# REVIEW COMMENTS

**FILE #**SPR-96-12

**TITLE HEADING:** Site Plan Review - Addition to an Existing Fourplex

**LOCATION:** 1105 Santa Clara

SITE & LANDSCAPE PLAN - FOURPLEX ADDITION  
1105 SAUNA CLARA AVENUE, SAN JOSE, CA 95128-95

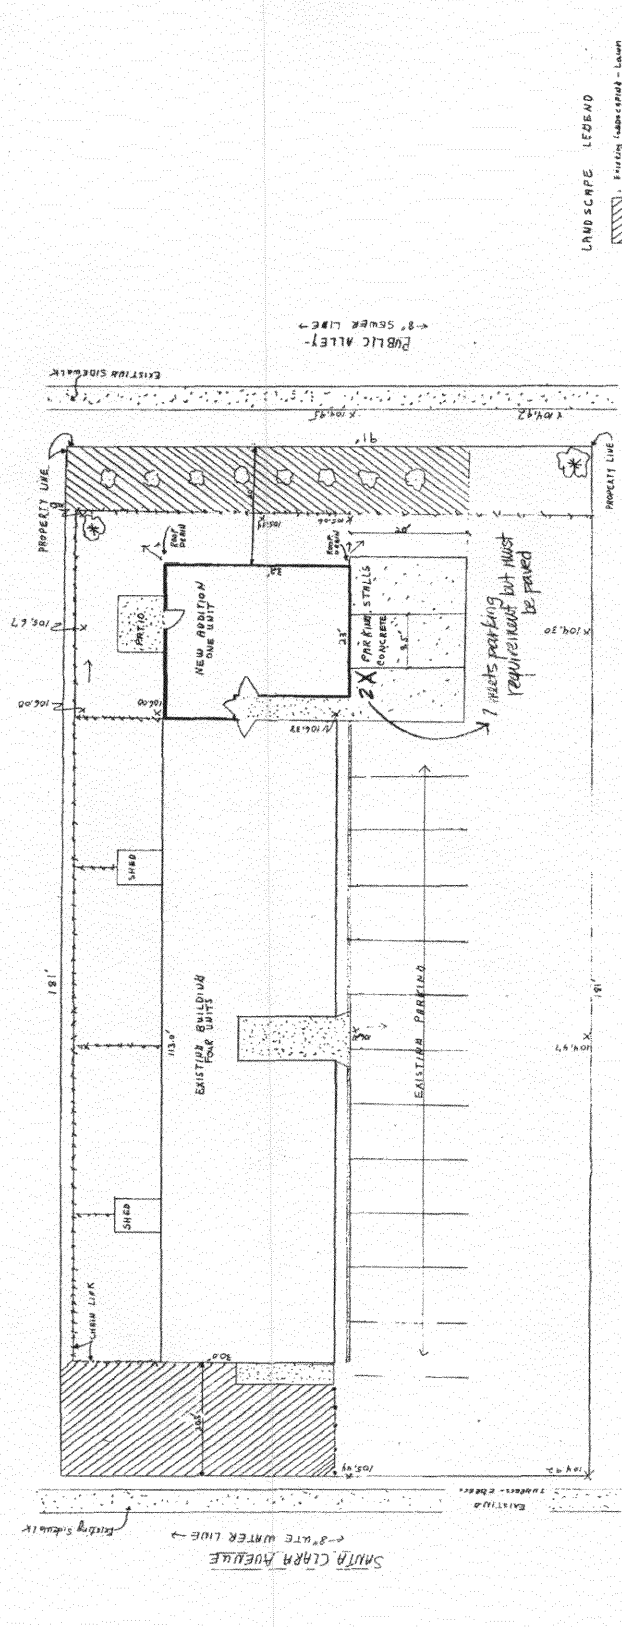
1. Transportation Capacity Payment - \$300.
2. Drainage - The site plan does not indicate runoff patterns. Please provide spot elevations and arrows indicating direction of flow. Increase in stormwater runoff to adjacent private property is prohibited. Discharge into the street is allowed with payment of a drainage fee.
3. Is the existing parking area paved?

1. Indicate surface of existing parking and show the layout of spaces in that area (NOTE: a total of 8 parking spaces are required).
2. Will yard area around the proposed units have grass or other plants? If so, indicate on plan.

1. Drainage: Spot elevations have been placed on the site and landscaping plan. It is my intention to have gutters on the East and West roof lines with downspouts on the Southeast and Southwest corners of the building. This will allow stormwater to flow South from the building. It is anticipated that most of the water will be absorbed into the soils. Any excess water will drain into existing streets to the South.

2. PARKING: There are currently 12 parking spaces for the 4-plex. The addition will have room for an additional 3 spaces. The 12 existing spaces have been added to the site plan. The surface of the existing spaces is dust-free gravel. The site plan for the addition shows 3 additional concrete parking spaces. However, I would like to request the planning staff allow me to use gravel for the 3 new spaces. The gravel has worked well in the past, and the concrete would, I feel, be an unnecessary expence.

3. LANDSCAPING: New landscaping is shown on the site and landscape plan on the South boundery of the property. (see landscape legend). I have not included any grass or other plants immediately around the proposed unit. I will probably have rock over AG cloth in the areas immediately around the proposed unit.

4. UTILITIES-SEWER AND WATER: There is an eight inch Ute water line in Santa Clara Ave. There is an eight inch sanitary sewer line in the road to the south of the property. These have been added to the site plan. Gary Mathews and Ute water has indicated there is a one inch water line serving the existing building, and Ute water will me to connect to the water line serving the existing building. If I am not able to easily connect with this line, I will connect to Ute water at Santa Clara. I would intend to connect with the sewer at the eight inch line in the street immediately to the south to the property.
